**PRODUCT:** Auditcon 2 Series & Cencon Dead Bolt Locks  
**BULLETIN:** #028  
**DATE:** 12/03/09

## High Security Locks for Secure Storage Units

### Cencon

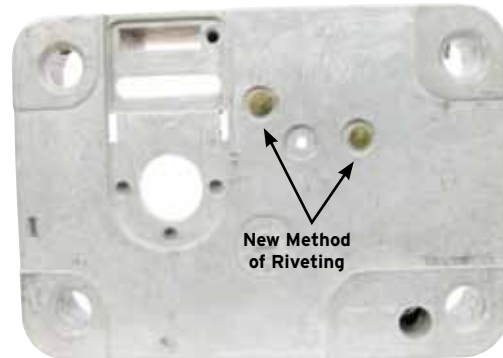
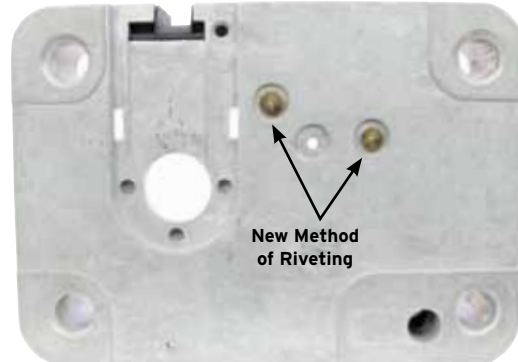
To ensure that our products continue to meet or exceed approval agency requirements, KABA's Auditcon 2 Series and Cencon solenoid dead bolt locks have been redesigned. The design changes include improvements to the solenoid, additional hardening of the bell crank latch, modifications to how the slider rests against the bell crank latch, and spin riveting of the bell crank mounting studs to provide greater holding strength. The design modifications have been completed and accepted by VdS.
